RE: **ABQ Biopark Elephant Exhibit**  
**903 10<sup>th</sup> St SW**  
**Engineer's Stamp Date 6/13/17**  
**Hydrology File: K13D034B**

**RE: ABQ Bio-park Elephant Barn (K13D034B)**

Attached with this letter is a revised Grading & Drainage Plan for the proposed Elephant Barn project at the ABQ Biopark. Revisions were made based on your review comments dated June 7, 2017. The following items correspond to your original numbered comments.

GRADING &  
DRAINAGE  
PLAN

CG-101

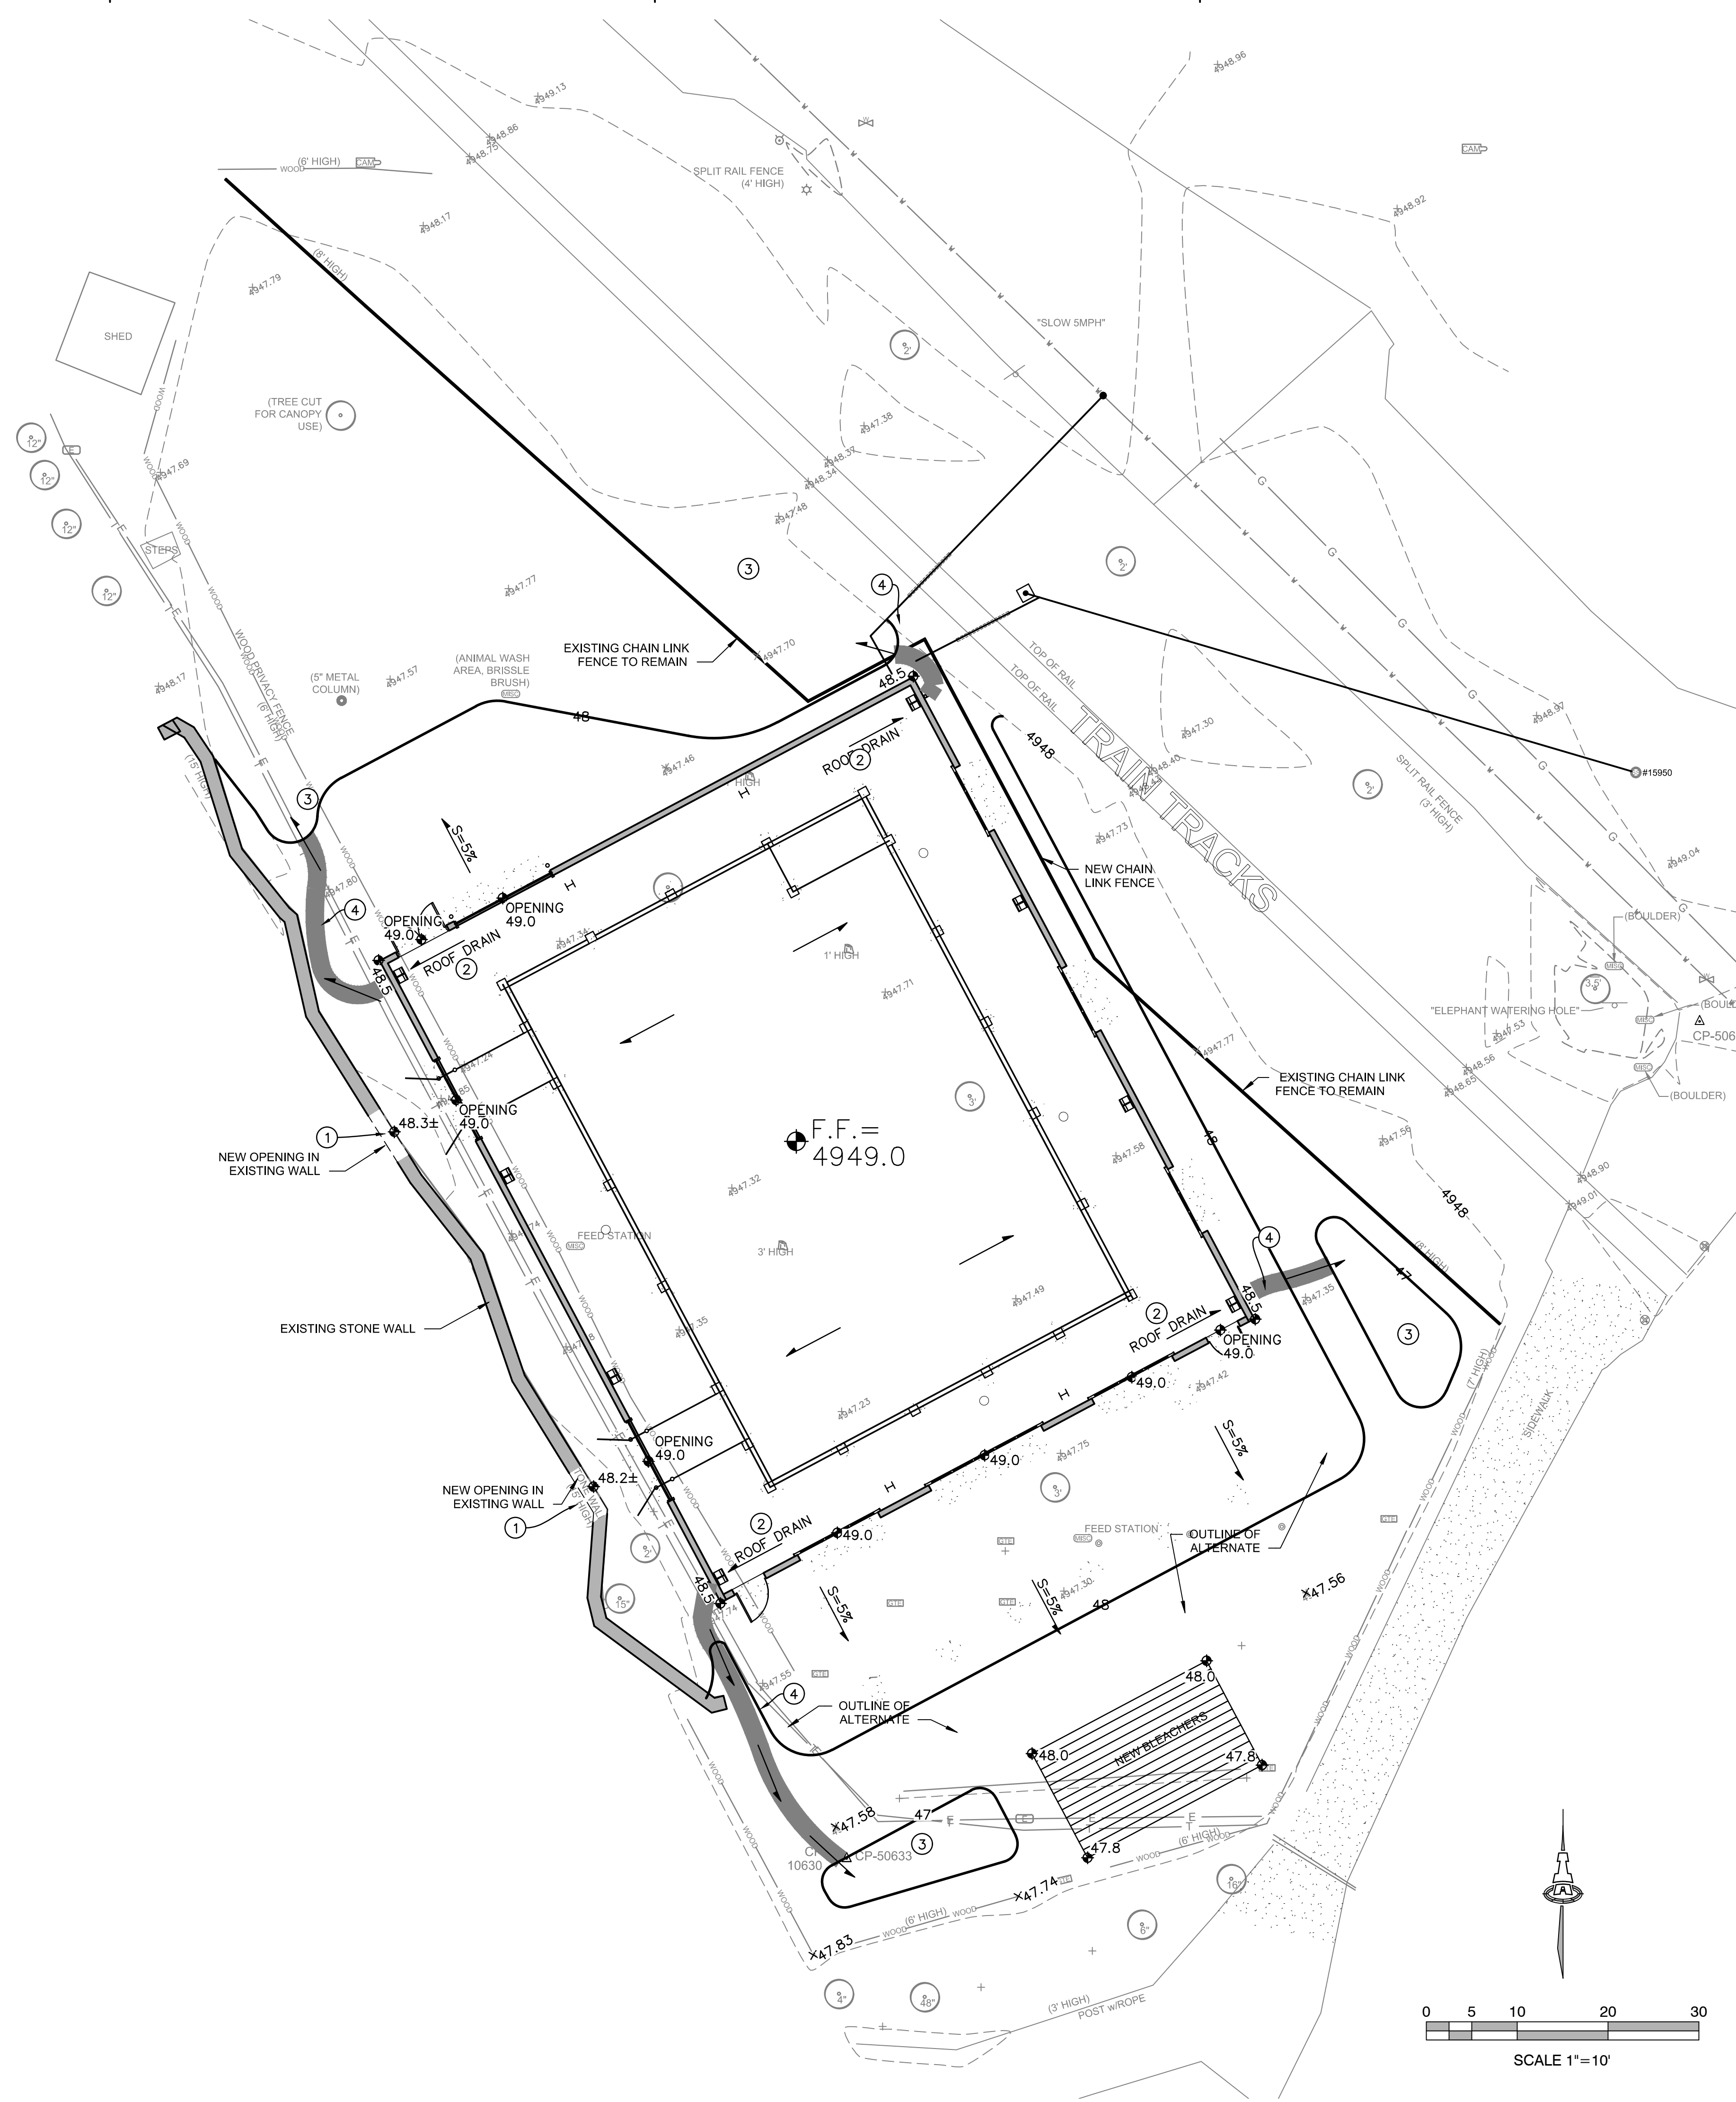
1. A supplemental information packet included with this submittal provides basin analysis and confirmation of the 100-year 10-day storm volume.
2. The maximum water surface elevation of 4948.5 has been noted on the plan.

3. The finished floor of the new elephant barn has been set to 4949.0 which is 0.5' above the MWSE. The reasons for this are:
  - a. The available volume at elevation 4949.0 is 28,225 cf which is 17,962 cf more than the 100-year 10-day volume of 10,263 requires.

- b. The barn is an open air enclosure with crusher fines & sand floor.
  - c. The access doors on the west side transition to existing over a short distance (7'±) which limits the FF elevation.

- d. Based on emails exchanged with the project architect, Robert Brumfield with Van H. Gilbert Architect, the building cannot be relocated because of potential interference with the existing train tracks. He has discussed this with his project contacts at the biopark.

Based on the information provided in the submittal received on 6/14/17 the above-referenced Grading and Drainage Plan is approved for Building Permit.

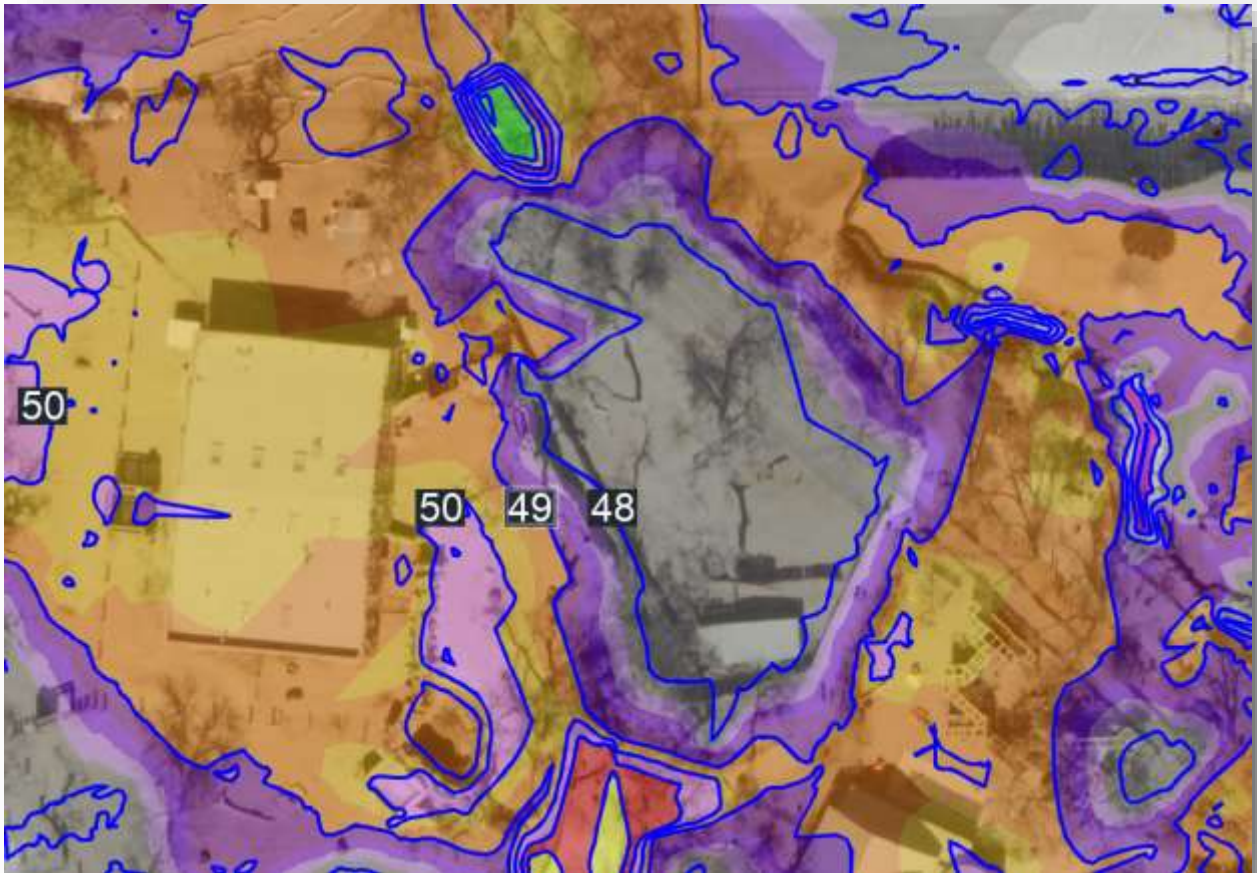
In the existing condition, the 100-year 10-day volume is stored with an estimated maximum water surface elevation of 4948.30 (see hatched area below).

At a FF elevation of 4949.0, the proposed building will displace approximately 4800 cf. The result will be raise the maximum water surface elevation (100-year 10-day storm event) approximately 0.2' to 4948.5.

The proposed barn consists of an open air enclosure with crusher fines and sand floor. The standard rule of setting a finish floor elevation 1' above the maximum high water elevation is not warranted with this project. For this reason, the FF elevation is set to 4949.0 which is 6" above the maximum high water elevation.
